SUBJECT: Forwards responses to 970331 RAI re proposed mod of Ginna spent fuel storage pool.

Subject: Response to Request for Additional Information - Spent  
Fuel Pool (SFP) Modifications - SFP Cooling Concerns (TAC  
No. M95759)  
R.E. Ginna Nuclear Power Plant  
Docket No. 50-244

By Reference 1, the NRC staff requested additional information  
regarding the proposed Modification of the Ginna Spent Fuel Storage  
Pool dated March 31, 1997. Enclosed are responses to each of the  
questions submitted by the NRC staff.

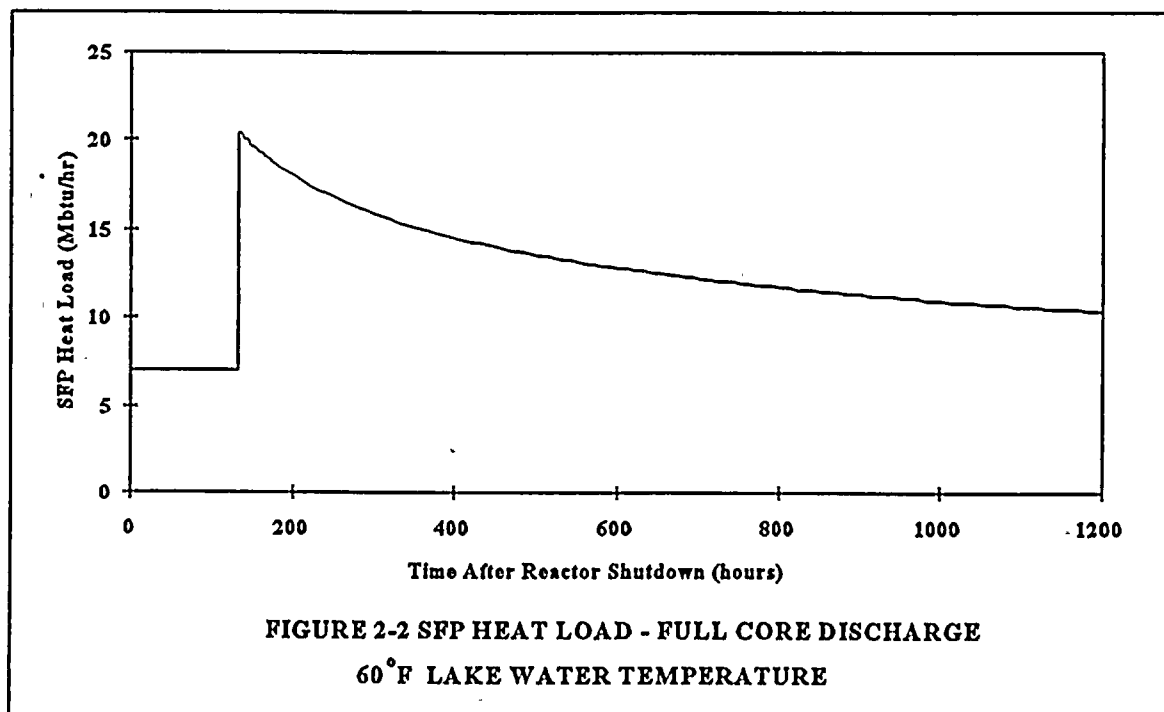
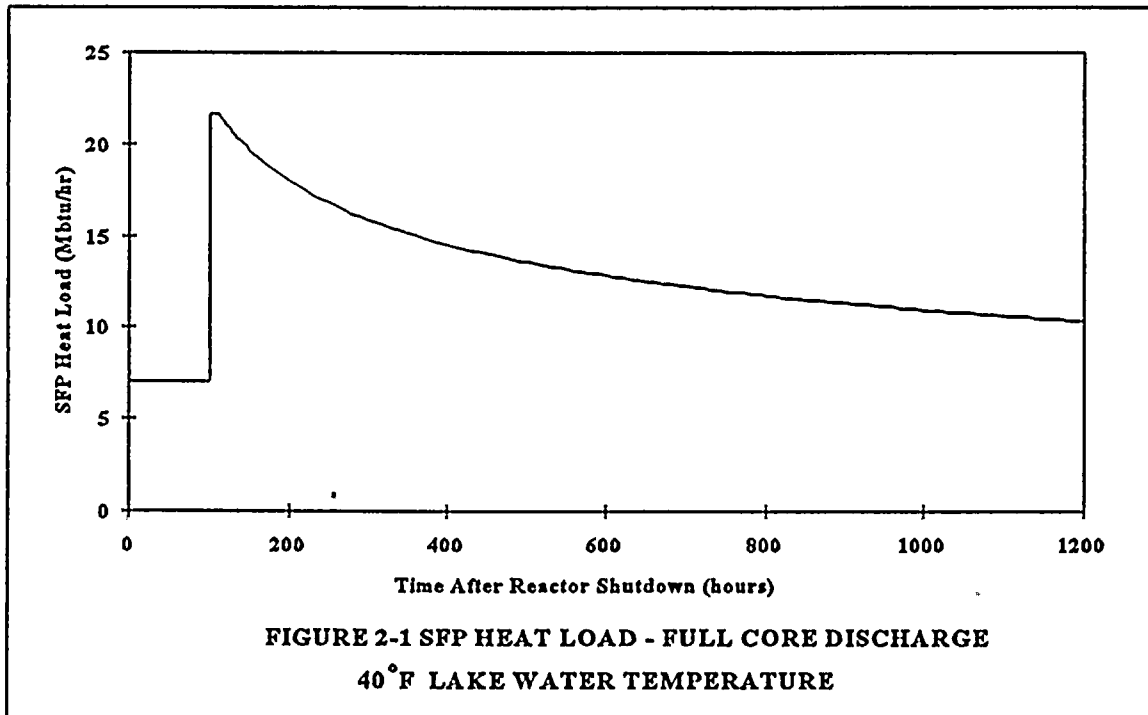
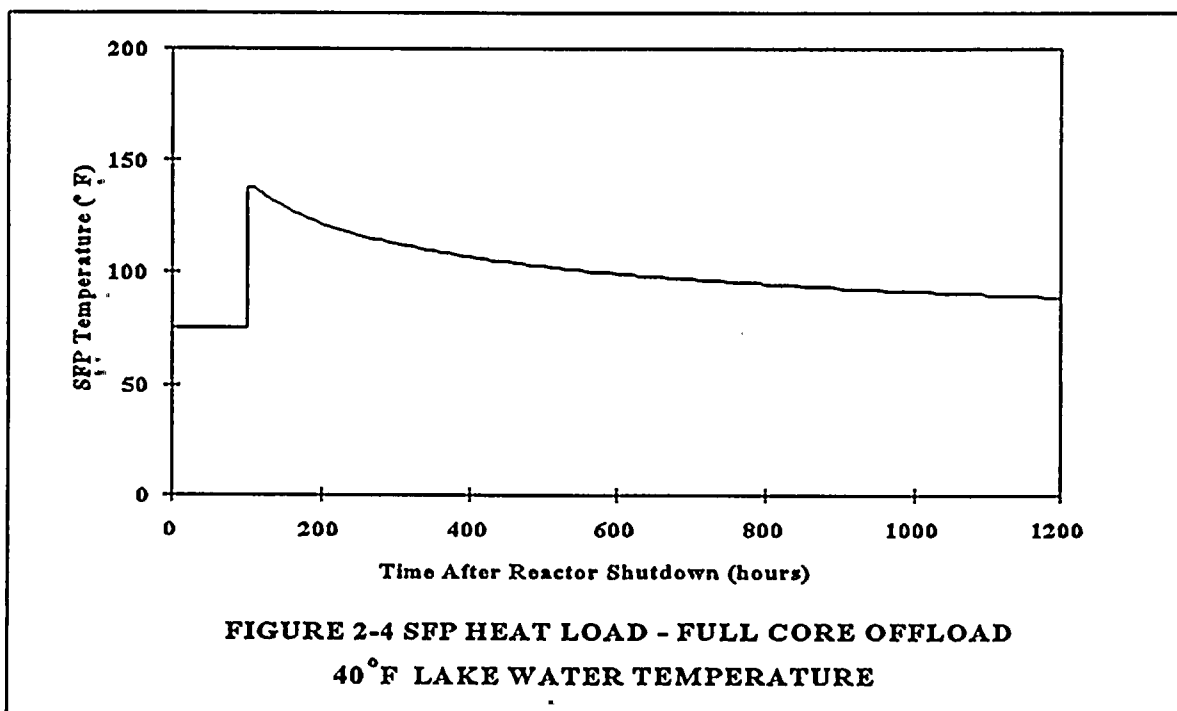
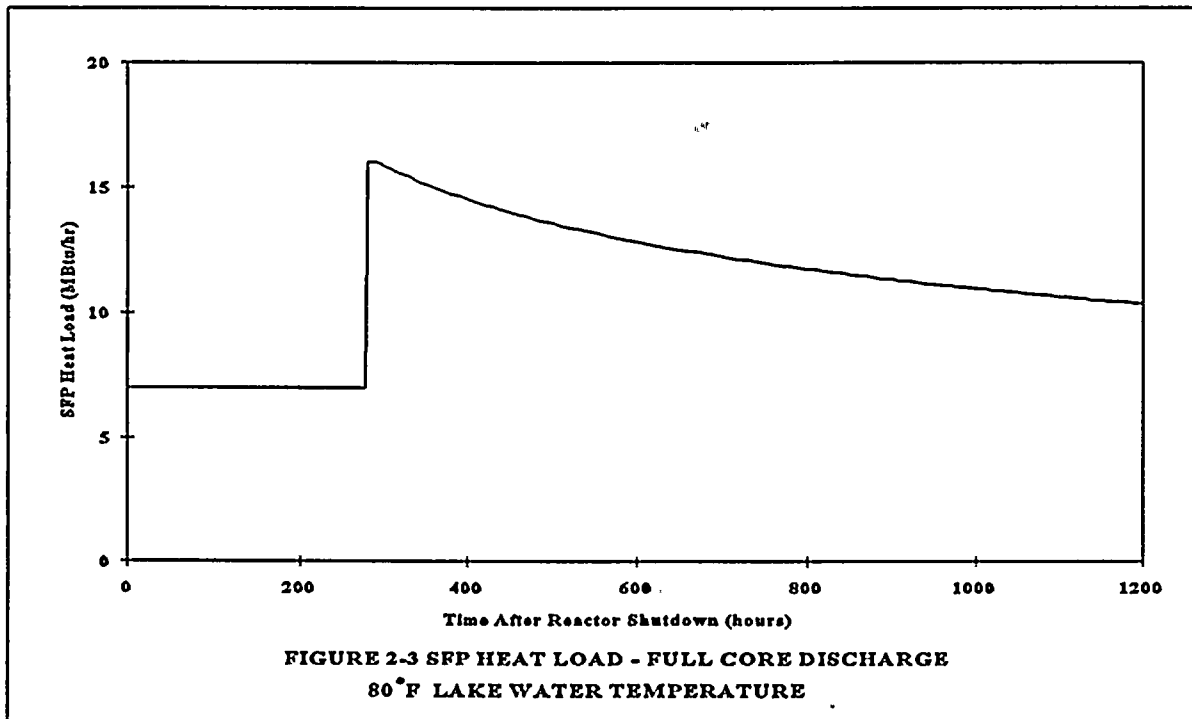
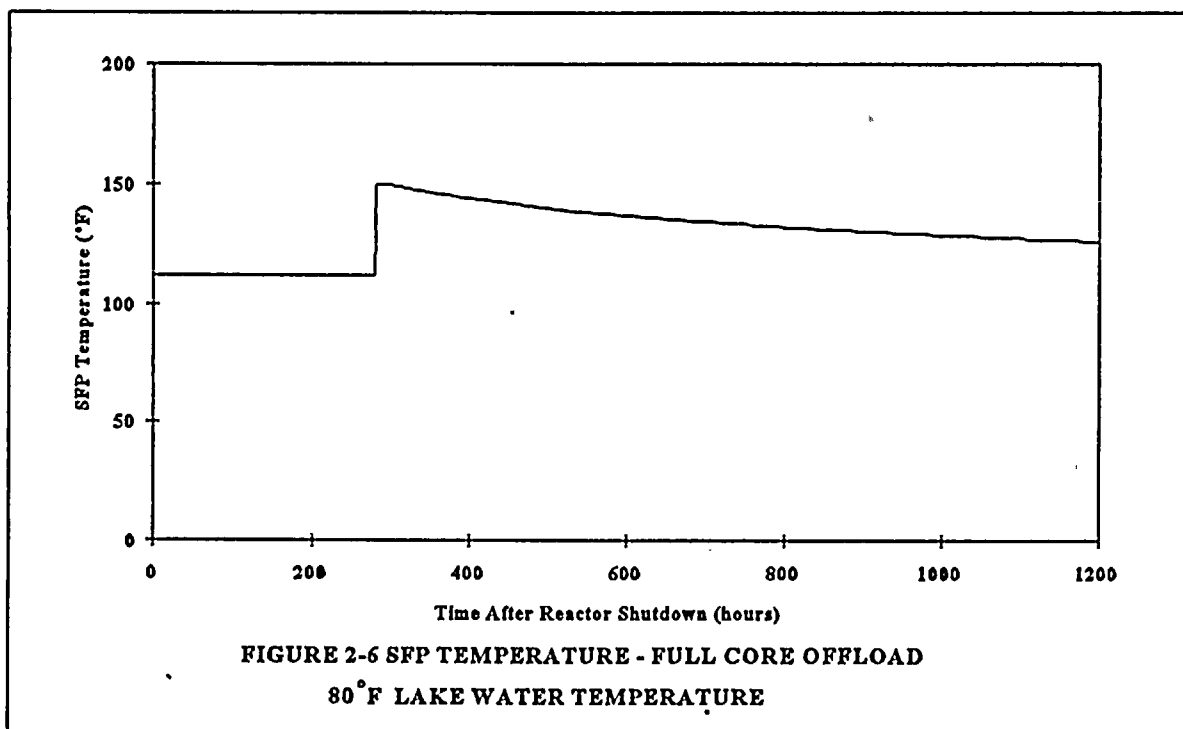
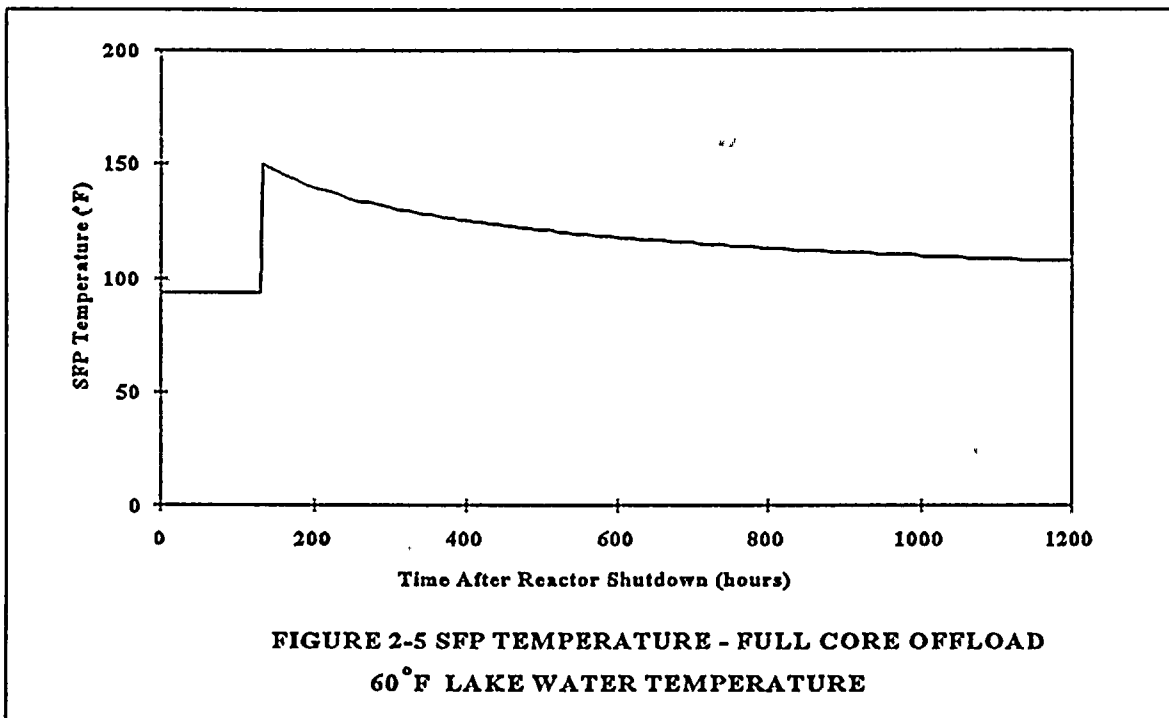
*In Section 5.7 of the SFP Re-racking Licensing Report, Ginna states that the technical specification (TS) limit for the SFP water is 150°F which is achieved with the present SFP cooling system. The heat removal capability of the SFP cooling system heat exchangers varies as the temperature of Lake Ontario water varies. Therefore, the duration of reactor shutdown required prior to any SFAs discharged to ensure that the SFP water temperature does not exceed its 150°F limit is a function of Lake Ontario water temperature. For a full core off-load scenario, the following summarizes the reactor shutdown times required prior to the discharge of any SFA for three lake temperatures (40°F, 60°F, and 80°F) to prevent the SFP water from exceeding the 150°F limit:*

*Have these restrictions required for SFAs to decay in the reactor prior to the discharge of any SFA been incorporated in the Ginna TS? If not, provide detailed justifications for not having these restrictions imposed in the TS.*

*Also, provide the decay heat loads in the SFP and the corresponding calculated SFP water temperatures as a function of reactor shutdown time for each of the above cases.*

The decay heat load vs. time used for the full core off-load for each of the Lake Ontario water temperatures is shown in Figures 2-1, 2-2, and 2-3. The increase in SFP heat load above the background value in the figures corresponds to the placement of the full core off-load in the SFP after the required in-reactor decay time.

The SFP temperature vs. time for a full core off-load scenario at each of the lake water temperatures is provided in Figures 2-4, 2-5, and 2-6. These SFP bulk temperatures were calculated for an instantaneous placement of the full core in the SFP, neglecting the thermal inertia of the SFP and using design conditions for fouling and tube plugging for the SFP heat exchangers.

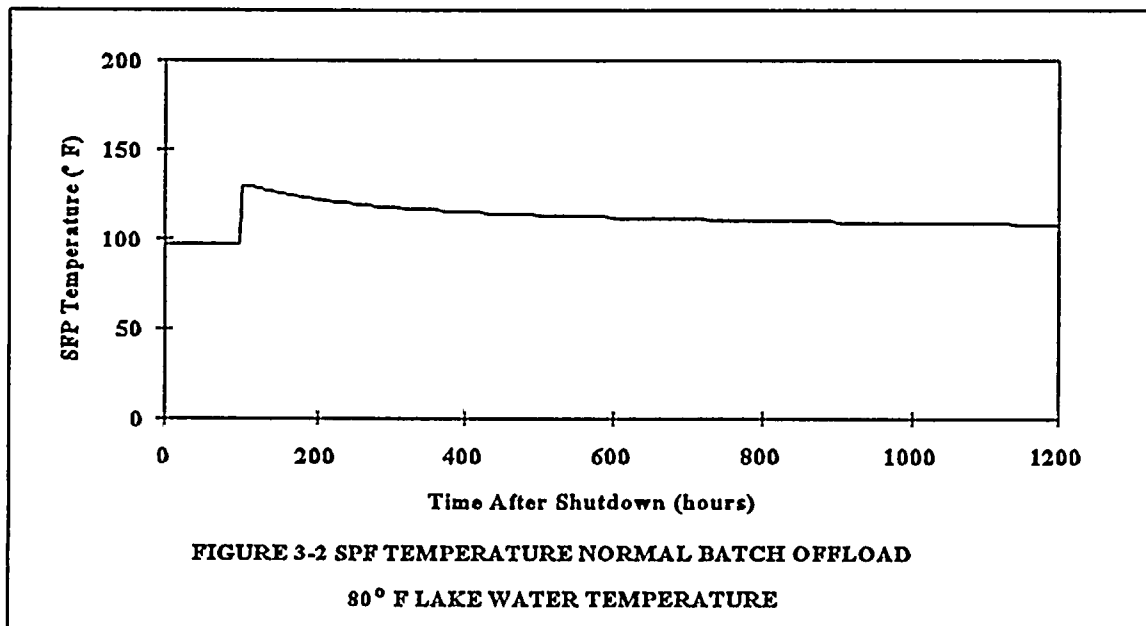
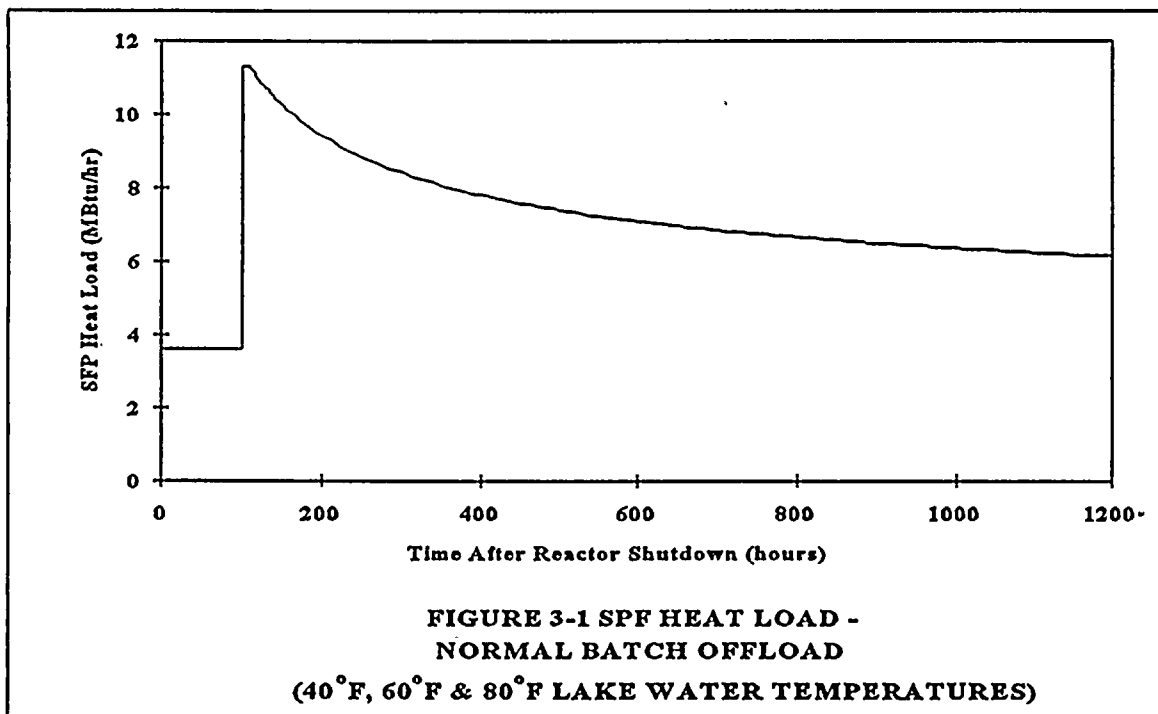
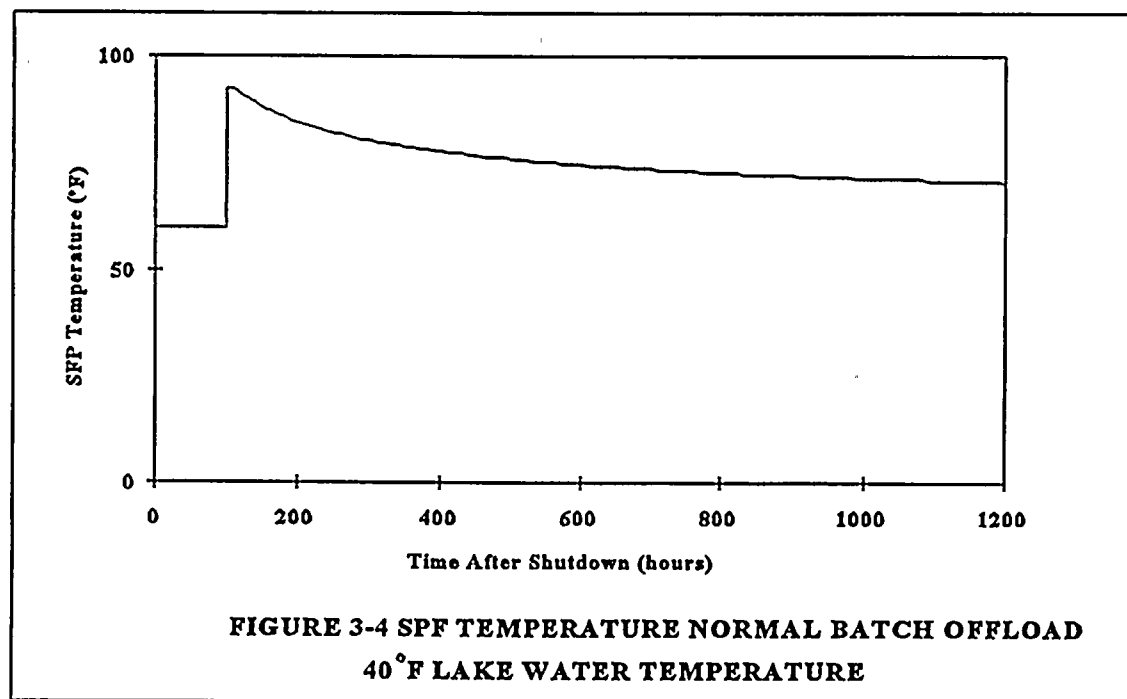
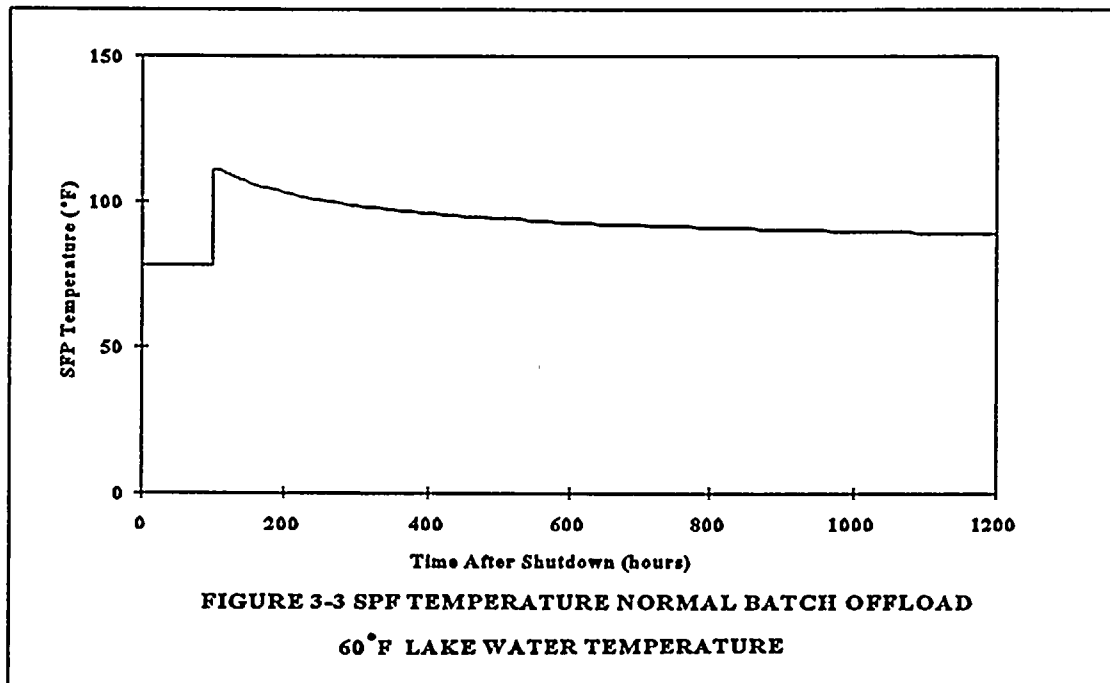
*For the normal (routine refueling with 1/3 core discharged) discharge scenario as discussed in Section 5.5.2.1 of the SFP Re-racking Licensing Report, provide the decay heat loads in the SFP and the corresponding calculated SFP water temperatures as a function of reactor shutdown time. Also, indicate the lake water temperature which was used in the analysis.*

This limiting design decay heat load vs. time used for a 1/3 core off-load is shown in Figure 3-1. The increase in SFP heat load above the background value 100 hours after reactor shutdown in the figure corresponds to the placement of the 1/3 core off-load into the spent fuel pool.

The corresponding SFP temperature vs. time for a 1/3 core off-load at each of the Lake Ontario water temperatures are provided in Figures 3-2, 3-3, and 3-4. These SFP bulk temperatures were calculated for an instantaneous placement of the 1/3 core in the SFP after the minimum required 100-hour decay time. The thermal inertia of the SFP was neglected and design conditions for fouling and tube plugging were used for the SFP heat exchangers.
